Subject: RECALL 09V-219 – Emergency Exit Window Release Mechanism

RECALL #09V-219

MODEL: MINOTOUR

SUBJECT: EMERGENCY EXIT WINDOW RELEASE MECHANISM

FIGURE 1 - LOW-FORCE ACCESS REGION FOR EMERGENCY EXITS HAVING ADJACENT SEATS

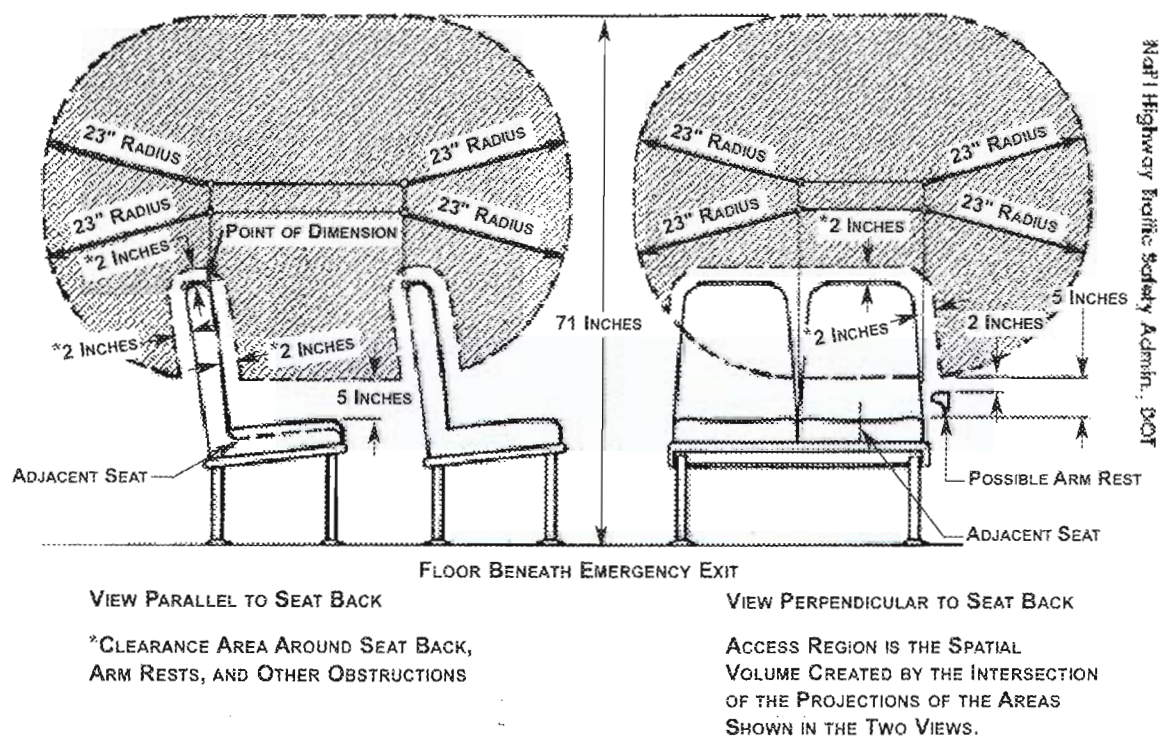
A minimum of two inches is required between an emergency push-out release handle and the adjacent seat. Check to see if your push-out window release handles are within the two inch minimum requirement.

If the handles are closer than two inches to any portion of the seat, continue with this repair. **Figure 1**

FIGURE 2

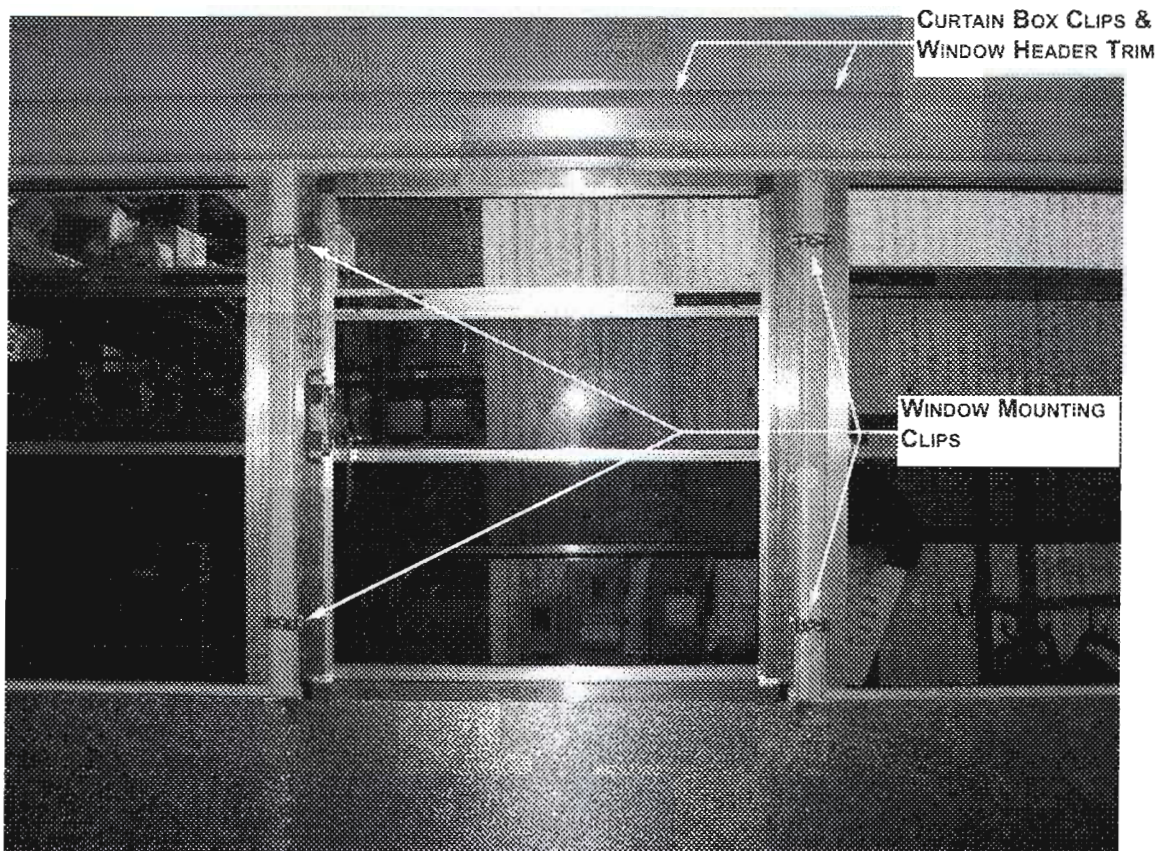
1. **IMPORTANT:** Before you begin relocating the Push-out window, verify that the new location will have the minimum two inches of clearance required between the release handle and the closest part of the seat.
2. Remove the curtain box clips and window header trim. **Figure 2**
3. Remove the four window mounting clips that retain both windows in the openings.

FIGURE 4

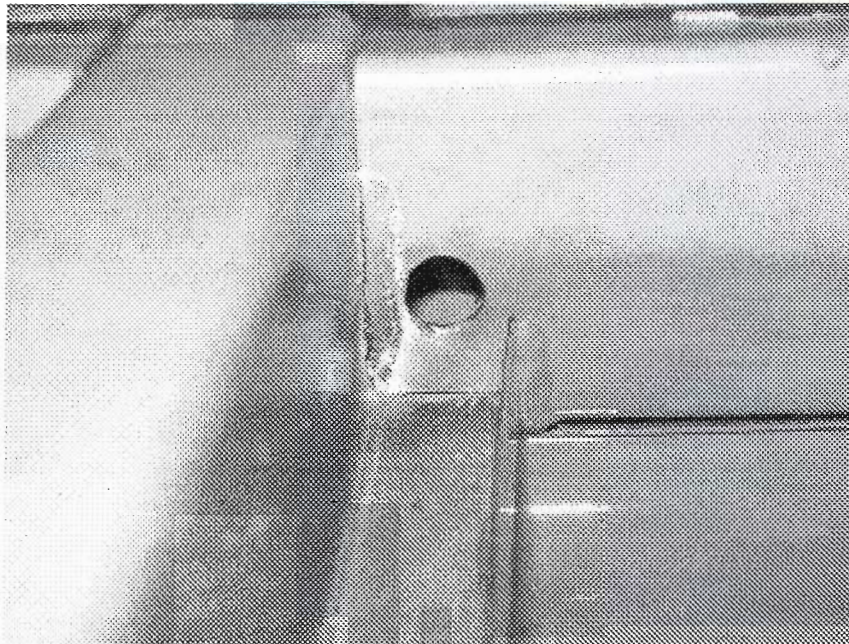
7. Lift the windows up and out of the openings.
8. Cut away any remaining raised sealant that may interfere with reinstalling the windows. Check the opening and window frame.
9. Inside the pilaster flange, on the handle side of the window, **(taking care to keep drill from contacting any wiring that may be above the window header)** drill a 0.375 dia. hole in the header of the new push-out window location. Figure 4

FIGURE 5

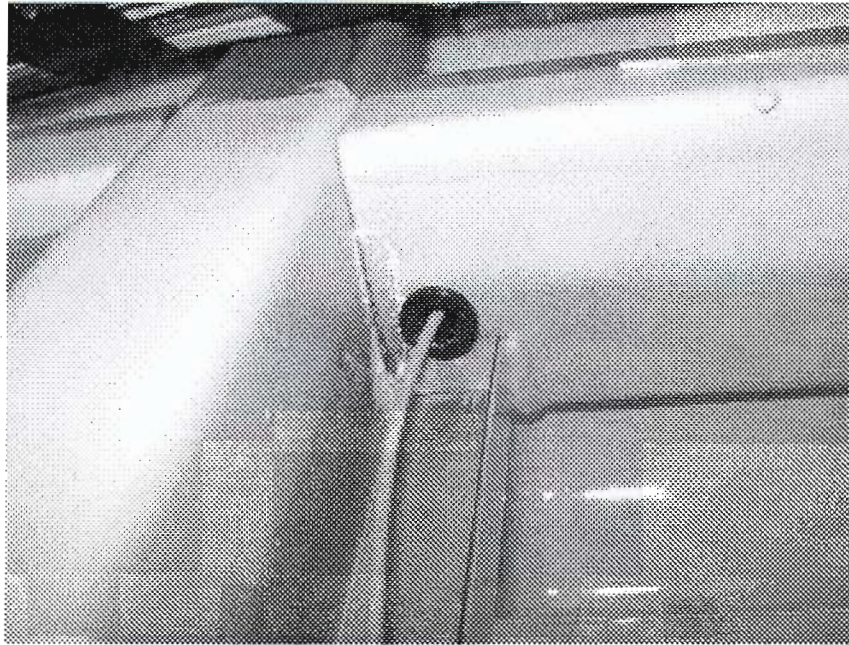
10. Insert Grommet, #TBB 22010379 into the 0.375 dia. hole from the bottom.
11. Route push-out switch wire from harness, down through the grommet at the new location. If the new location for the push-out moved toward the rear of the unit, use a Butt Splice, #TBB 22009377 and 18 GA. Wire, #TBB 163818 for the added length and route down through grommet. **Figure 5**

FIGURE 1

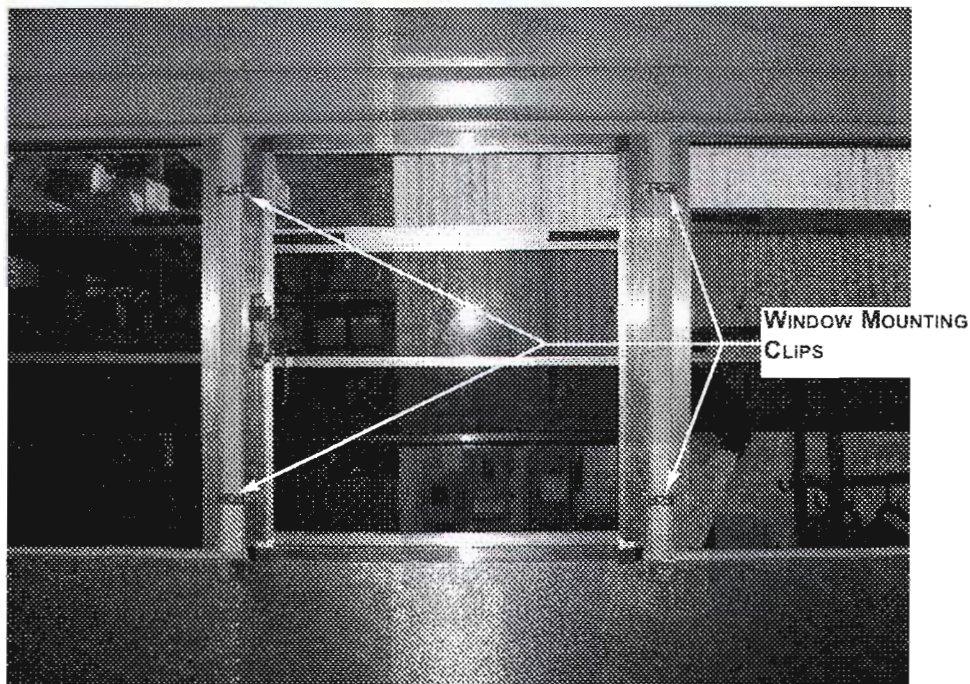
1. Remove the four (4) window mounting clips that retain the window in the opening; retain. **Figure 1**

FIGURE 2

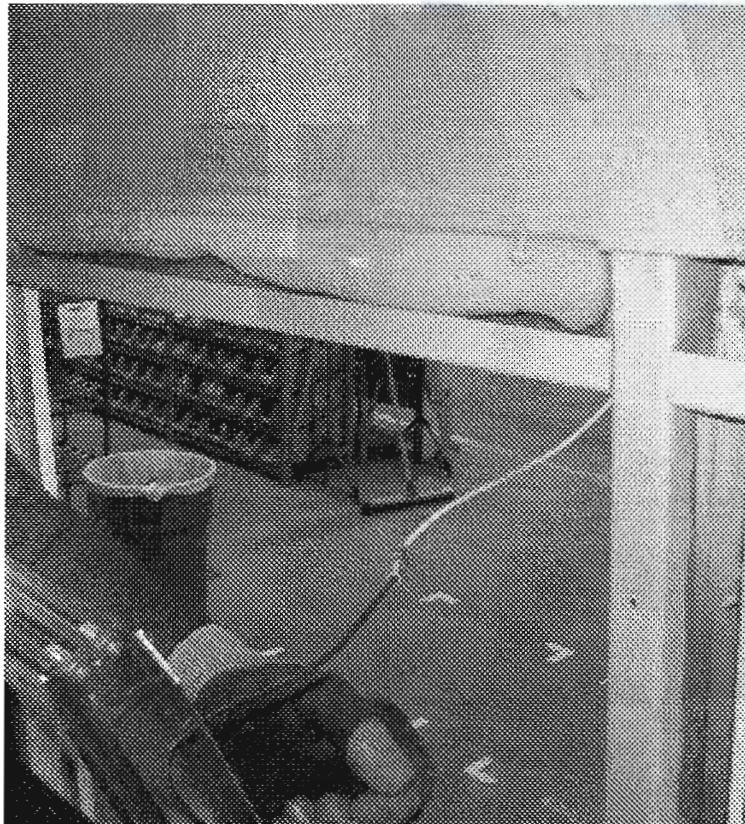
3. Lower the slider sash. Pull the top of the window frame inside the unit, so that the top of the frame clears the window header.
4. Cut the push-out window switch wire at the splice. **Figure 2**

FIGURE 3

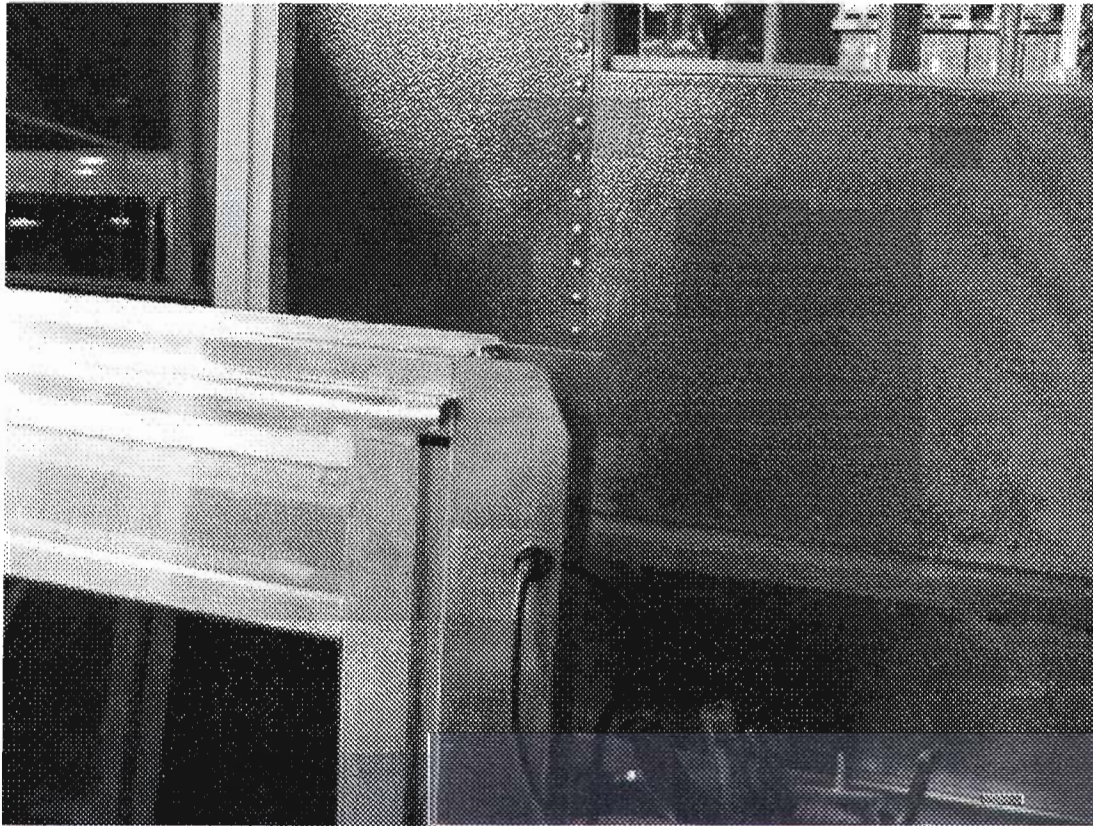
5. Lift the window up and out of the opening.
6. Cut away any remaining raised sealant that may interfere with reinstalling the window. Check the opening and window frame.
7. On the switched / wiring side of the window, using snips, cut an approximately $\frac{1}{2}$ " X $\frac{1}{2}$ " chamfer on the outer, top corner of the window frame. This creates clearance for the wire and grommet pass-through in the header. **Figure 3**
